Subject: Cable Tray Support Walkdown Questions  
Comanche Peak Steam Electric Station  
Independent Assessment Program - Phase 4  
Texas Utilities Generating Company  
Job No. 84056

**Attachment A**  
**Cable Tray Support Walkdown Questions**

ELEVATION OF SOUTHERN  
ANGLE BRACE FOR SUPPORT  
408, TYPE SP-8  
(NOT TO SCALE)

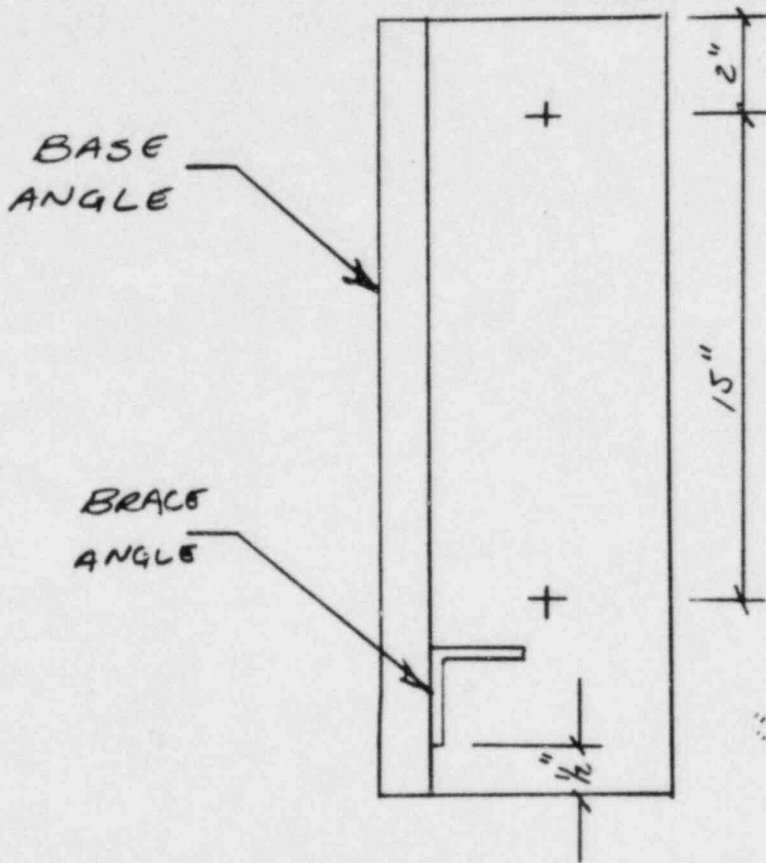
3. Support 455, Type: SP-8.

Cygna's walkdown documentation shows that the southern angle brace from the C6 x 8.2 vertical hanger member is attached to the base angle between the anchor bolt and the end of the angle as shown in the attached sketch. The original design configuration specifies that the brace shall be located between the anchor bolts with a maximum eccentricity from the bolt centerline. Cygna notes that the installed brace connection configuration matches the original fabrication drawing (Sheet 455, revision 2, of drawing FSE-00159). Please provide the existing calculations which demonstrate the acceptability of the installed brace connection configuration since it is different than the original design assumptions.

ELEVATION OF BRACE - CONNECTION  
TO BASE ANGLE  
DETAIL "N" - SUPPORTS 722 & 2606  
(NOT TO SCALE)

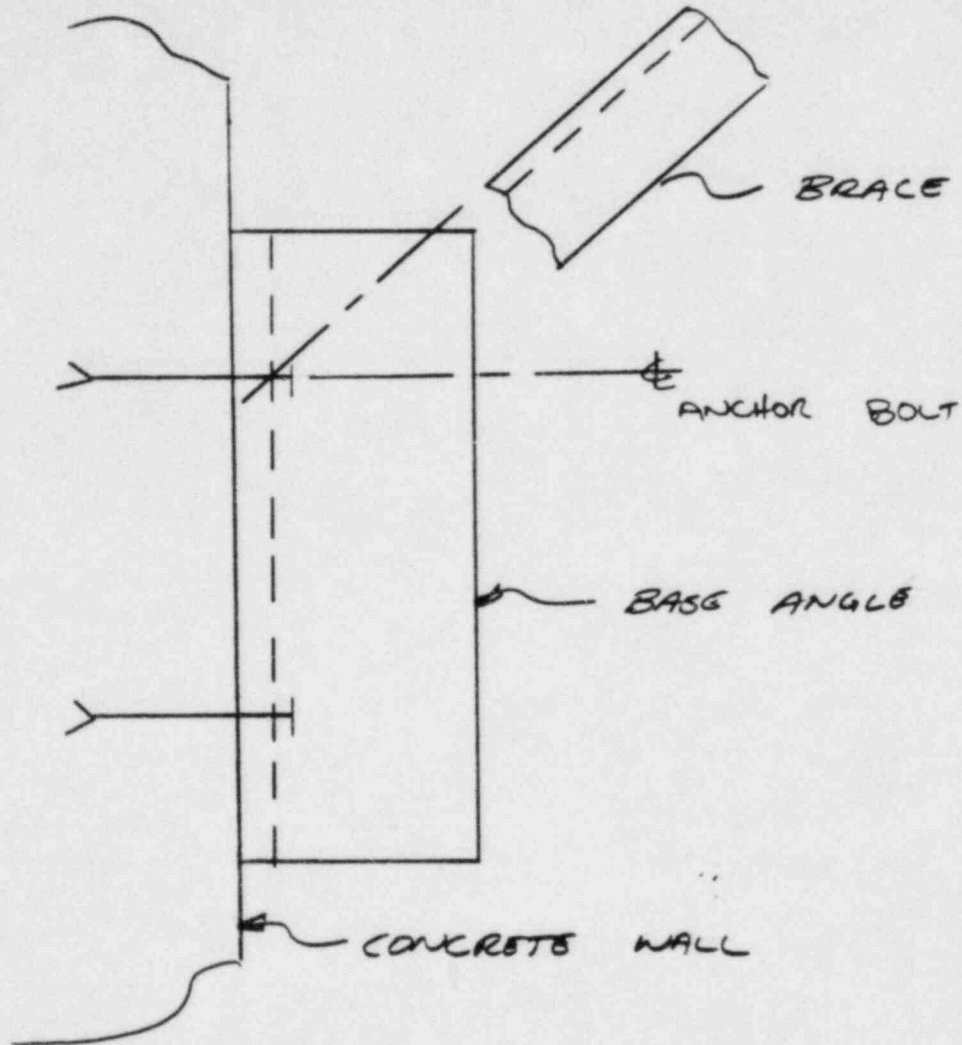
5. Supports 722 and 2606, Type: Detail "N", drawing 2323-E1-0601-01-S.

Cygna's walkdown documentation shows that the working point of the brace connection to the base angle is through the centerline of the top anchor bolt as shown in the attached sketch. This configuration forces the entire brace load to be resisted by a single anchor bolt which is not consistent with the original design. Please provide justification for the adequacy of the installed connections.

ELEVATION OF HANGER CONNECTION  
SUPPORT 6654  
(NOT TO SCALE)

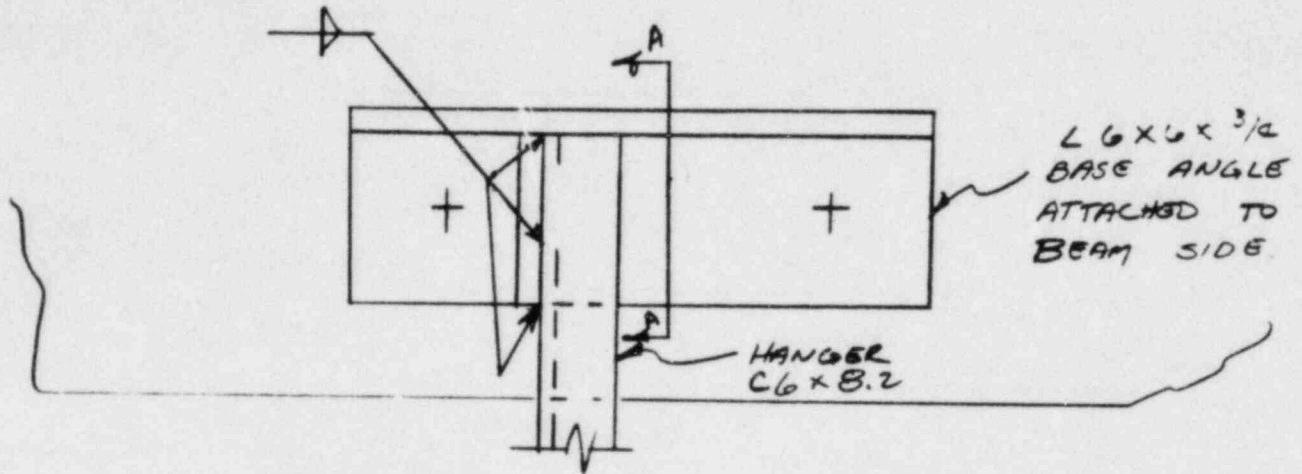
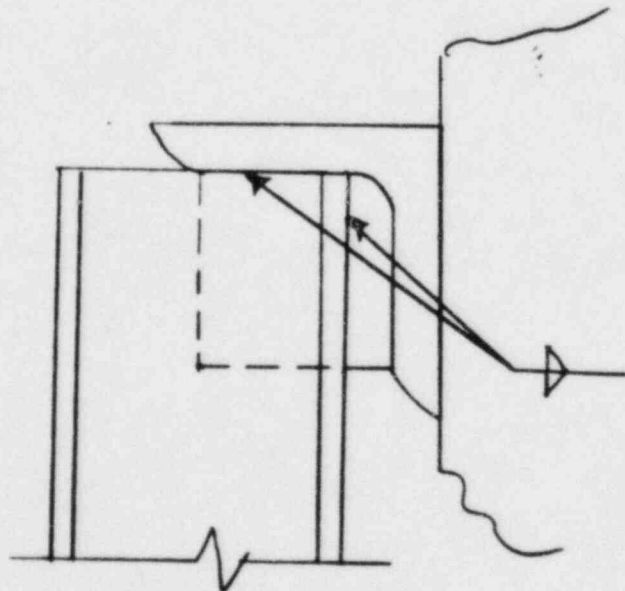
8. Support 6654, Type: A-2.

CMC 90714 details the connection between the east leg and the base angle of the support. The attached sketch shows the constructed configuration of the connection. The installed detail provides more weld length than originally specified, but the points of attachment and weld length are different than that specified on CMC 90714. Please provide documentation which permits the change in the connection detail as noted above.
